Cornelia Warren Park Improvements, 2019

ADDENDUM NO. 3

May 28, 2019

C2.1

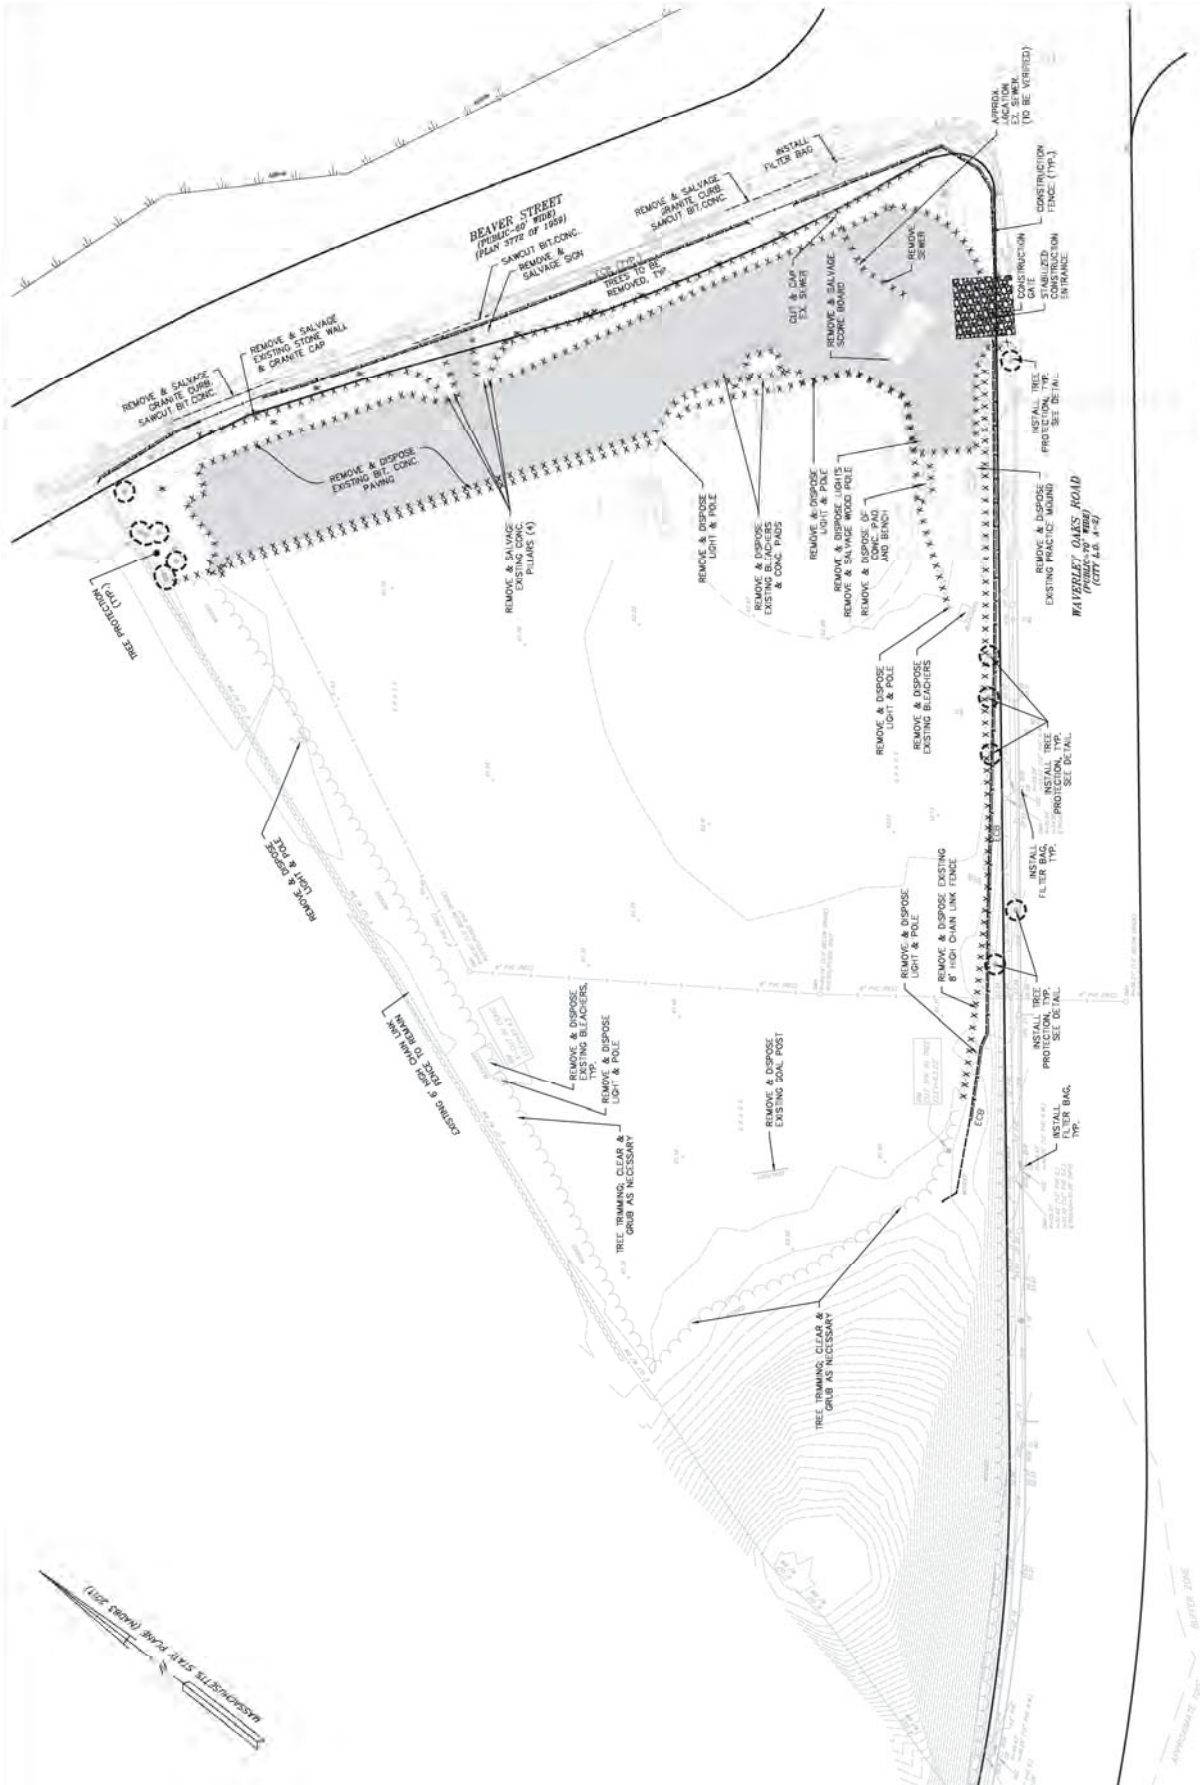
Drawing C2.1 has been revised to include: removing and salvaging one existing pole; removing and salvaging granite piers; and removing and capping existing sewer.

8-1 JOB NO. 2018-003
 8-1 PLAN NO. 2018-003-003
C-5.1

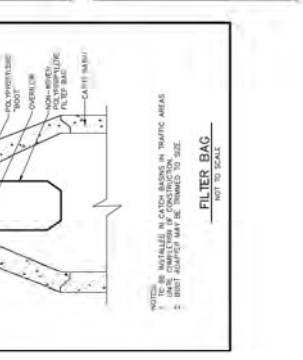
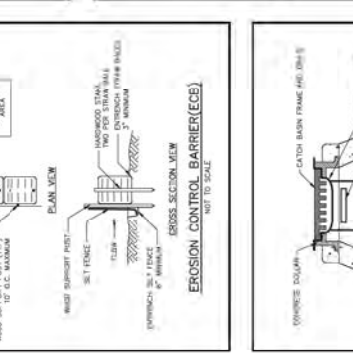
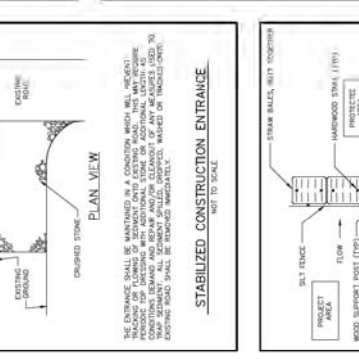
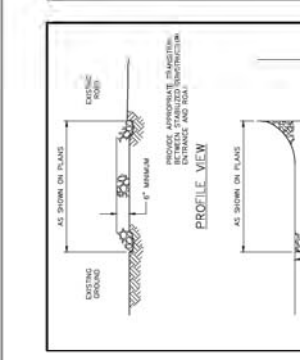
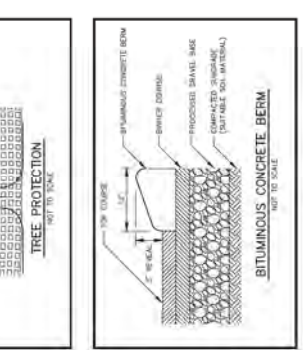
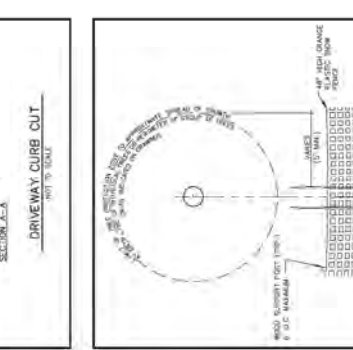
- Q16.** There are two pavement section details on C5.1, "Bit. Conc. Walk" and " Bit. Conc. Pavement". The combined asphalt thickness of the Bit. Conc. Walk is 3" and the combined asphalt thickness for the Bit. Conc. Pavement is 4". On sheet C3.1 all areas of asphalt pavement are labeled as "Bit Conc. Pavement" requiring 4" of asphalt pavement. Please confirm if this is the intent.
- A16.** No, the intent is that the "Bit. Conc. Pavement" detail is for the parking lot pavement, while the "Bit. Conc. Walk" detail is for the walking path and sidewalks. Detail sheet C5.1 has been revised to clarify the difference: "Bit. Conc. Pavement (vehicular)" shall be a total thickness of 4" in the parking lot. "Bit Conc. Pavement (sidewalk)" shall be a total thickness of 3" in all other non-vehicular pavement areas.

Drawing C5.1 has been revised to clarify bituminous concrete details: vehicular vs. sidewalk.

C5.2

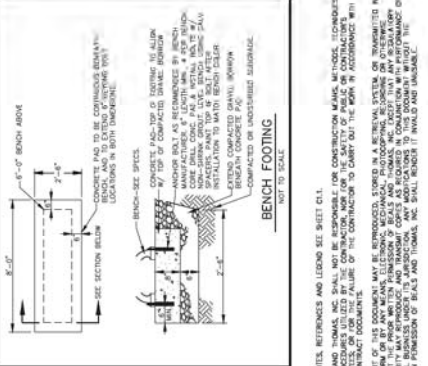
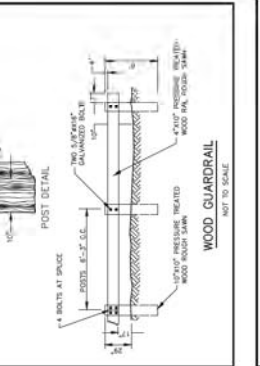
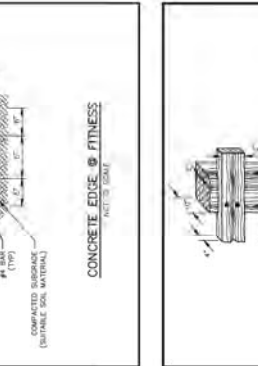
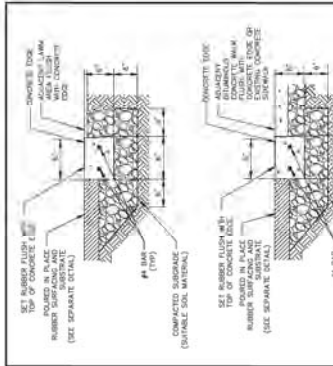
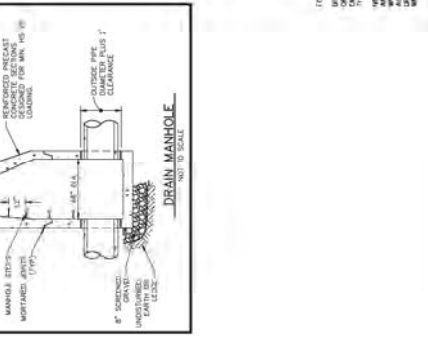
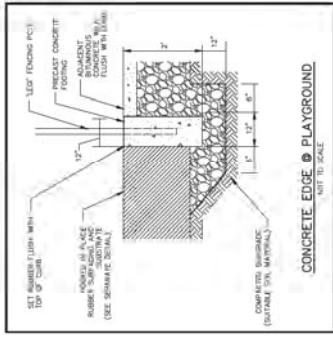
Drawing C5.2 has been revised to re-name wood "guiderail" to wood "guardrail".

B-1 JOB NO: 2018-030
B-1 PLAN NO: 2018-030-008
C5.4

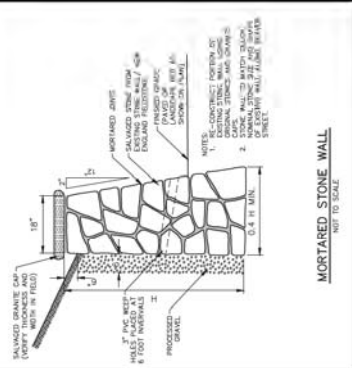
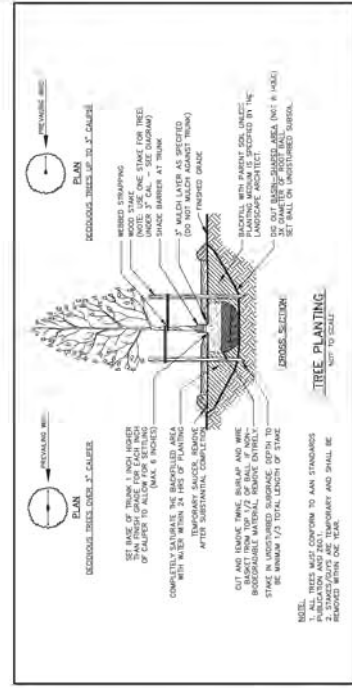
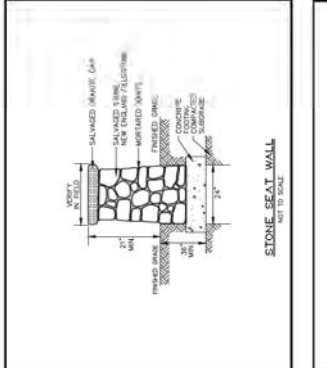
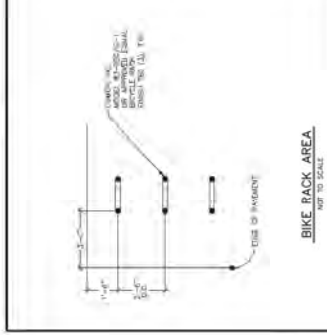
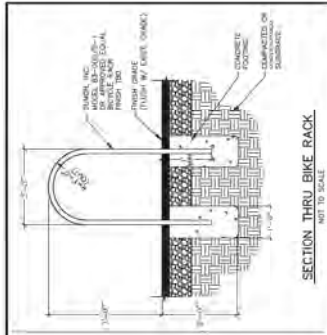
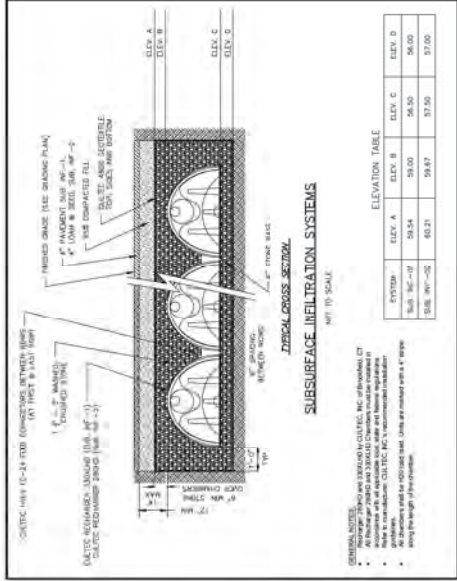
Drawing C5.4 has been revised to add "Drain Splash Block" detail.
